Applies To: **2007–08 Odyssey** – Check the iN VIN status for eligibility

**November 27, 2013**

## Safety Recall: 2007–08 Odyssey VSA System Unexpectedly Activates (Supersedes 13-098, dated November 6, 2013; see REVISION SUMMARY)

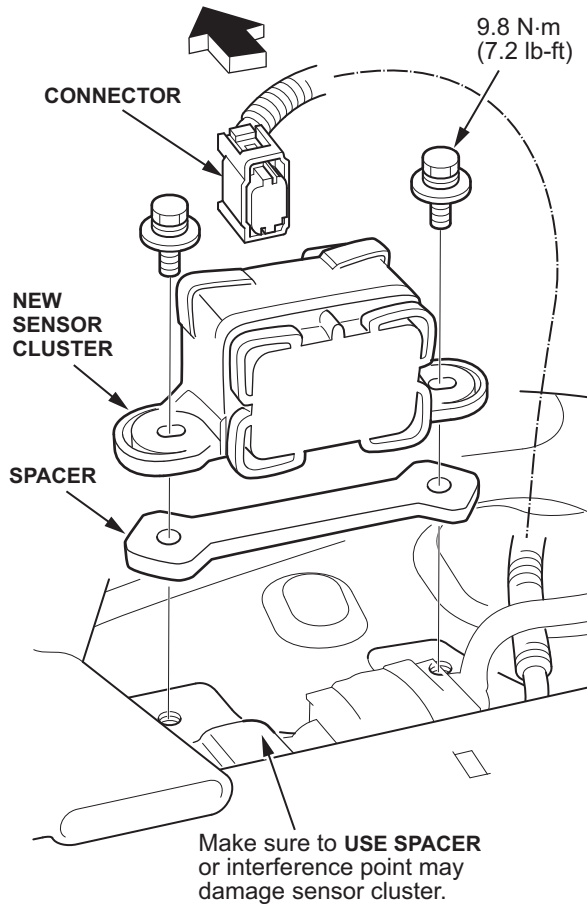
13. Install the new sensor cluster and the new spacer with new bolts. Torque the bolts to **9.8 N·m (7.2 lb-ft)**. Reconnect the connector.

- Make sure to install the spacer. There is an interference point on the floor that can damage the new sensor cluster if the spacer is missing.
- Make sure the sensor cluster is installed in the correct direction; the connector should be toward the front of the vehicle.
- Make sure no wires or other debris is pinched between the body, the spacer, and the sensor.
